Post Accident AP1000 Containment Leakage

An Unreviewed Safety Issue

Fairewinds Associates, Inc, April 21, 2010

A Report by Arnold Gundersen, April 21, 2010
Chief Engineer, Fairewinds Associates, Inc

- Figure 1 – AP1000 in normal operation.
- Figure 2 – AP1000 design basis accident begins.
- Figure 3 – AP1000 containment hole opens as containment fills with radioactive gases.
- Figure 4 – AP1000 chimney effect draws radioactivity directly into the environment.

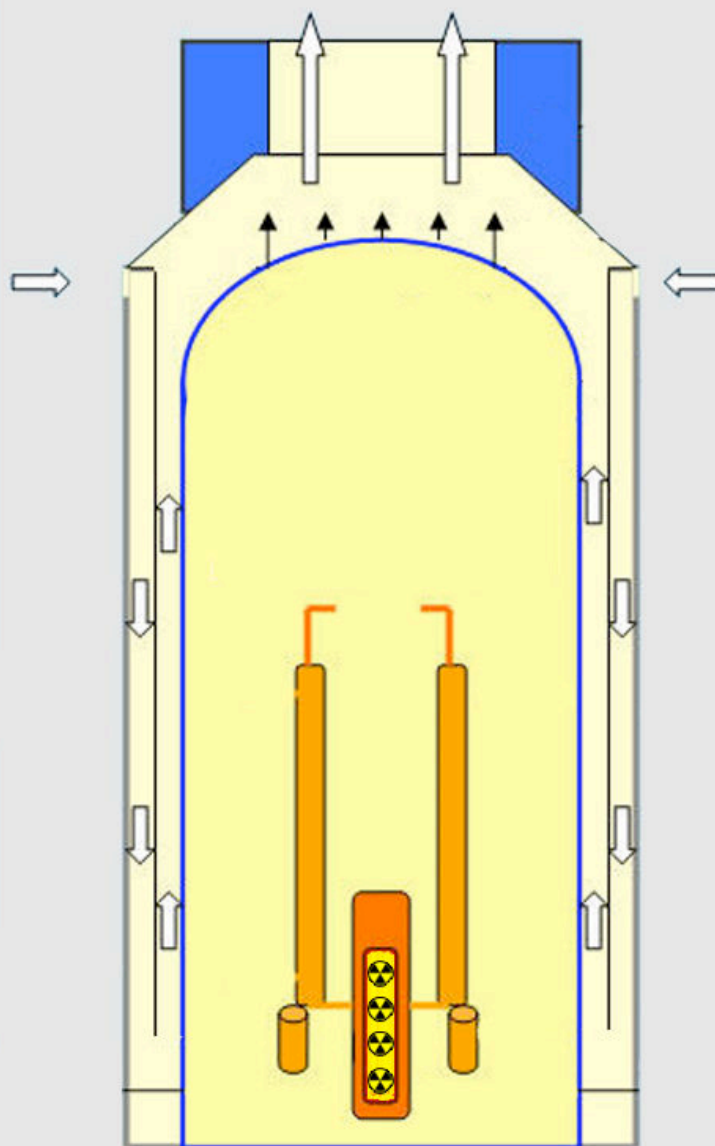
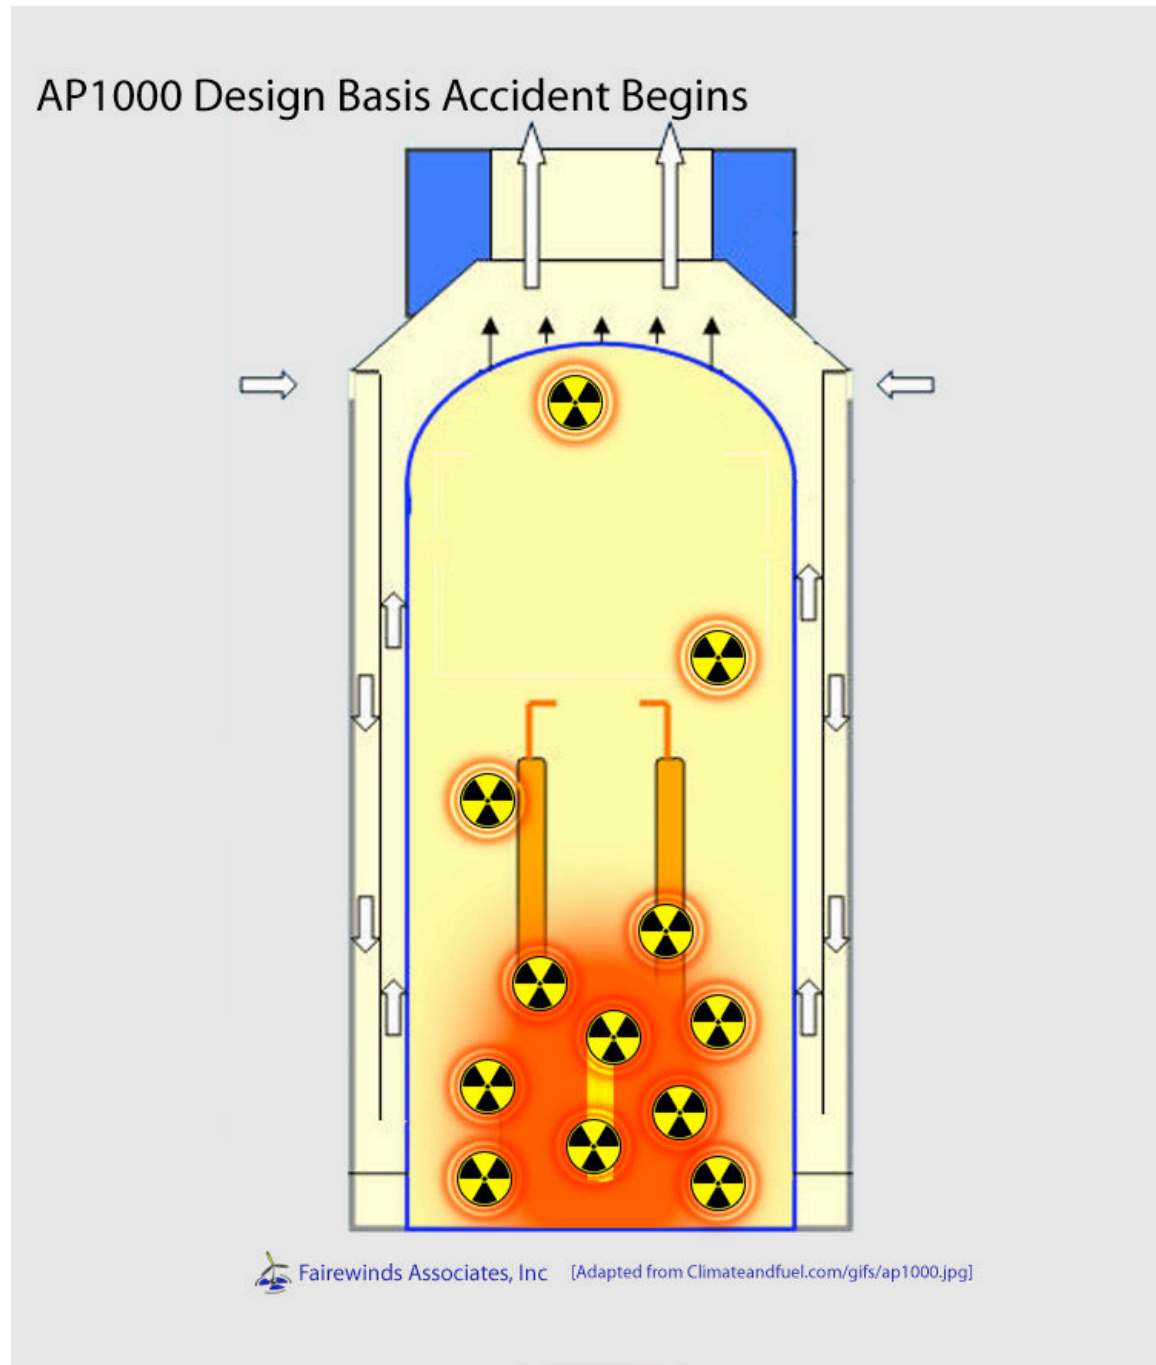
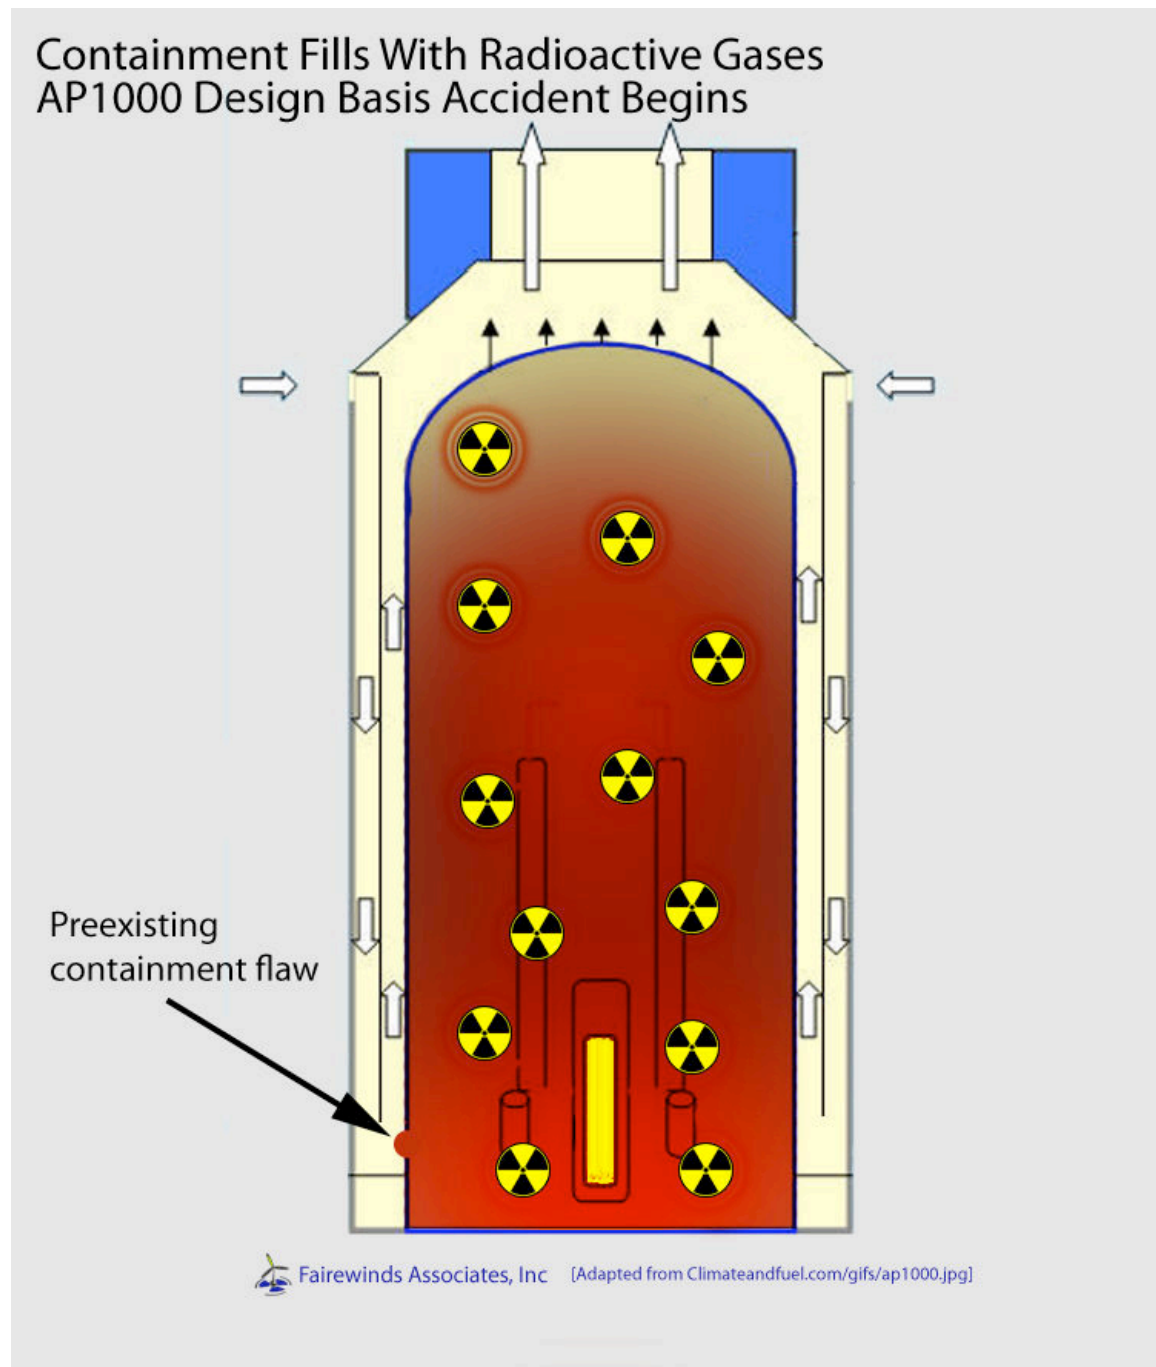
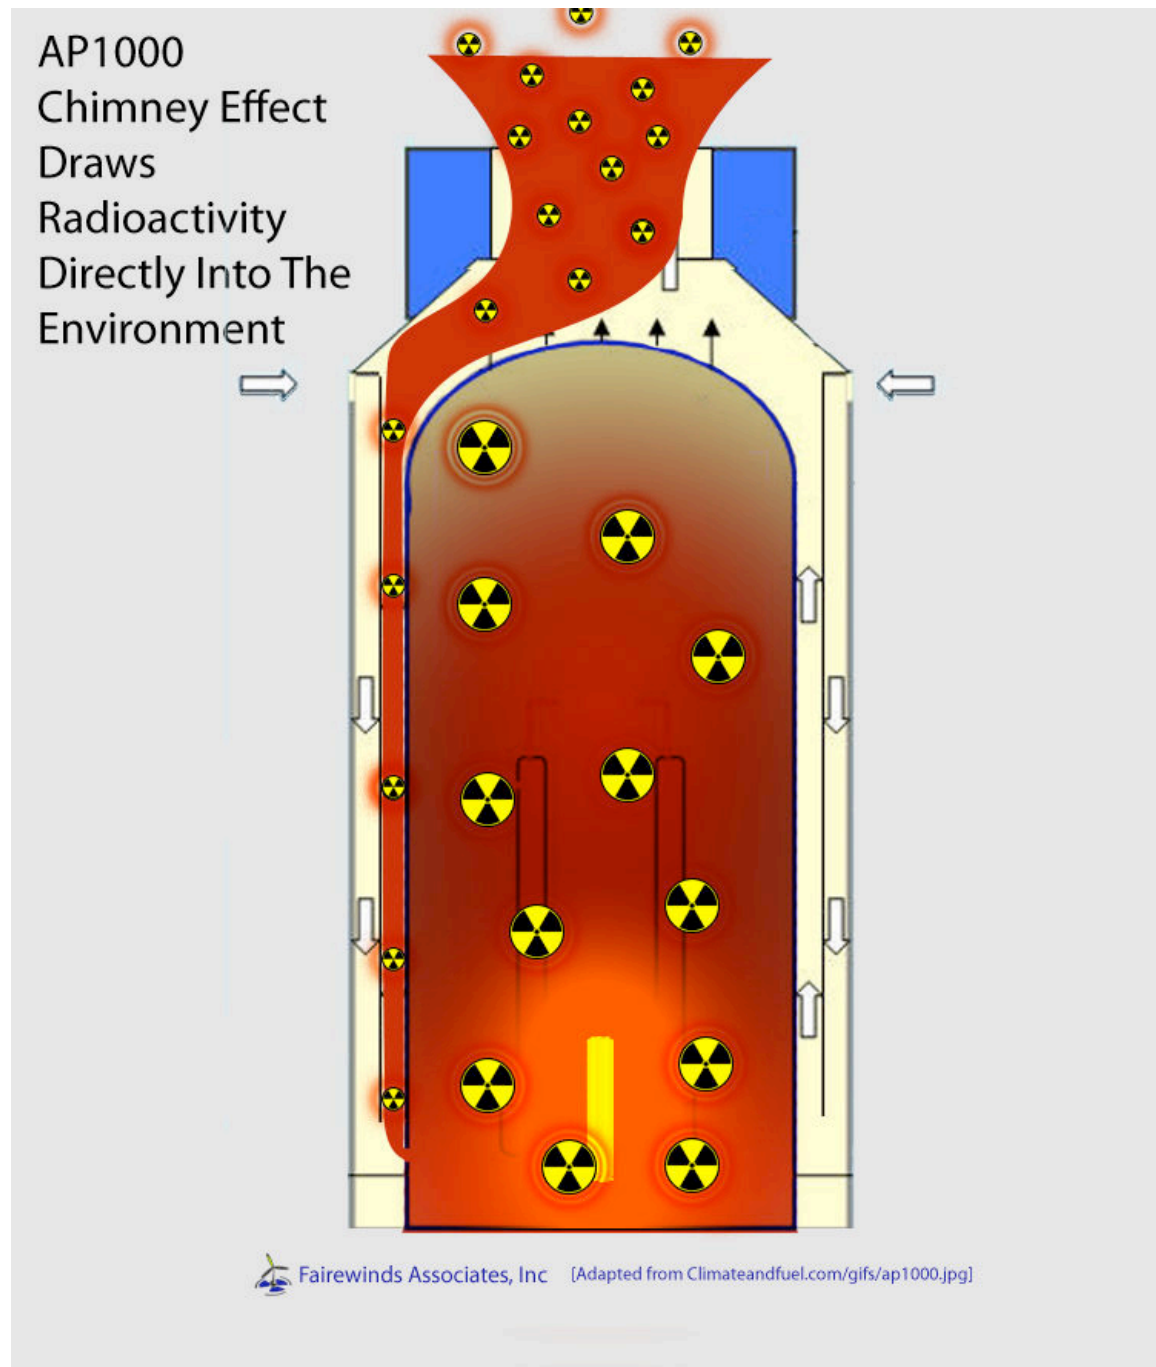
Containment system leakage from through-wall holes in steel has already occurred at North Anna, Beaver Valley, Hatch 1, Hatch 2, Cook and Brunswick. However, in each of these circumstances ACRS member Shack articulated the fact that there was another potential barrier by which to collect and filter the airborne radiation that leaked from the containment system. Previous freestanding steel containments with holes were enclosed within a reactor building into which the leakage entered and was controlled. The liner failures appeared to be backed up by a concrete containment building.

In the event of an accident at a proposed AP1000 reactor, leakage through the freestanding steel containment will pass directly into the gap between the steel and the shield building. Therefore, the proposed AP1000 containment design is inherently less safe than current reactors presently licensed and operating.

Concernedly, the hybrid AP1000 containment system appears to lack any of the redundancy or defense in depth²² in containment system design that was present in earlier designs reviewed in this report and upon which *design bases events* are predicated.
